The Horsley Drive upgrade between M7 Motorway and Cowpasture Road

Submissions report

Roads and Maritime Services | December 2018

Prepared by GHD and Roads and Maritime Services

Figure 4-1 Location of the businesses assessed in the BIA (Source: SMEC, 2017 – modified by GHD)

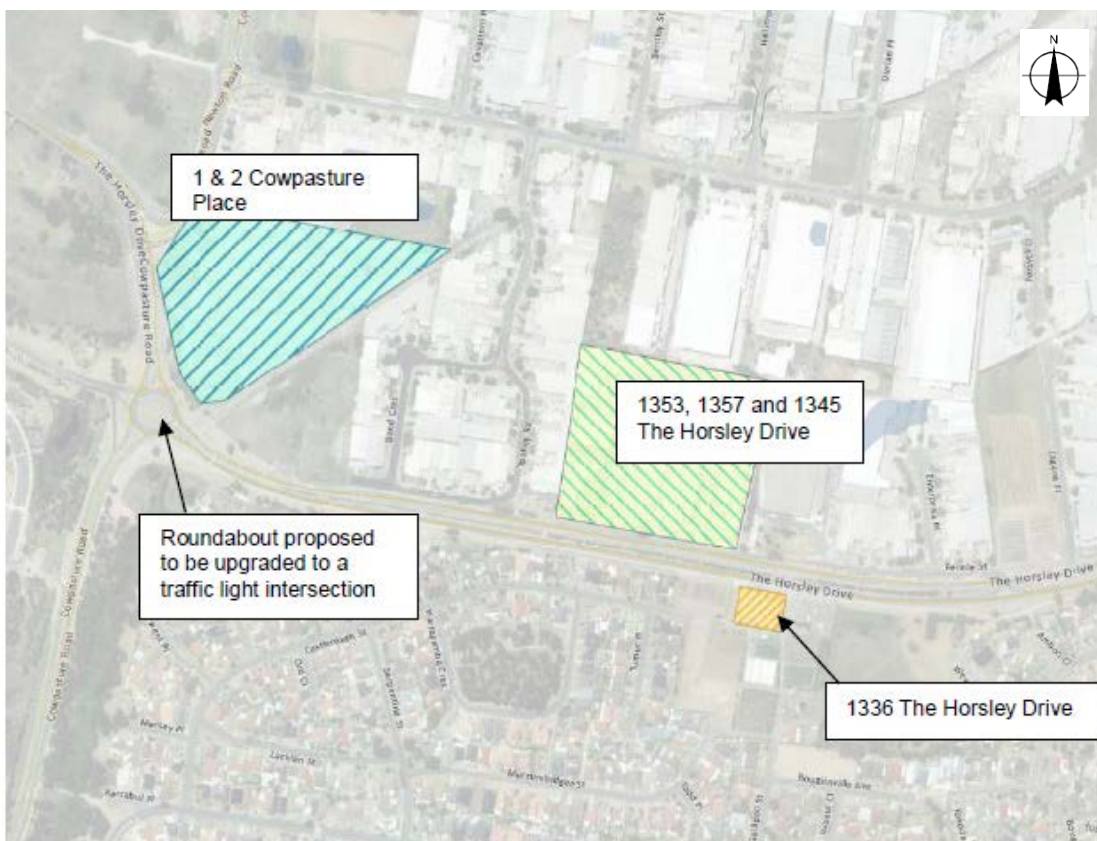
As a response to numerous submissions received regarding the change in traffic conditions and property access as a result of the signalisation of The Horsley Drive/Cowpasture Roads intersection, Roads and Maritime engaged GHD to prepare a Business Impact Assessment (BIA). This assessment aimed to understand the potential impacts to businesses located at three sites to the east of the roundabout at The Horsley Drive and Cowpasture Road.

The locations of these sites are shown in Figure 3-1. There are approximately 90 businesses located across these sites.

The access arrangements for customers and delivery vehicles visiting businesses at this location would not change as a result of the proposal. However, customers and delivery vehicles exiting this site with the intention to travel west on The Horsley Drive or north on Cowpasture Road would be required to take an alternate route as they would no longer be able to make a u-turn at The Horsley Drive/Cowpasture Road roundabout.

Based on the outcomes of the BIA, it is unlikely that the small increase in travel distance for some customers would deter them from visiting these businesses. Given that deliveries are scheduled and correspond to business agreements, it is considered that the delivery vehicles exiting to the west or north are likely to plan their journey ahead to meet their schedules.

Customers and delivery vehicles travelling to businesses at this location from the east would be required to take an alternative route as they would no longer be able to perform a u-turn at The Horsley Drive/Cowpasture Road roundabout. This would mean a potential increase in travel distance of 1.1 kilometres (around 3.7 minutes) or 2.4 kilometres (around four minutes), depending on the chosen alternative. The access arrangements for customers and delivery vehicles traveling from the west along the Horsley Drive or north/south along Cowpasture Road would not change as a result of the proposal. There would also be no change to customers and delivery vehicles exiting the site as a result of the proposal.

The access arrangements for customers and delivery vehicles visiting this business would not change as a result of the proposal. However, customers and delivery vehicles exiting this site with the intention to travel east along The Horsley Drive would be required to take an alternate route as they would no longer be able to make a u-turn at The Horsley Drive/Cowpasture Road roundabout. This would result in a potential increase in travel distance of up to 2.4 kilometres or four minutes. The existing arrangements for customers exiting the site to other directions, such as west on The Horsley Drive or north/south on Cowpasture Road, is not expected to change as a result of the proposal.

Based on the outcomes of the business impact assessment, given the type of specialist products and services offered at the business (nursery and farming) and that it receives some appointments, it is likely that customers would plan ahead to intentionally visit the business. It is unlikely that the potential increase in travel distance when exiting the site to some of the customers would deter them from visiting the business.
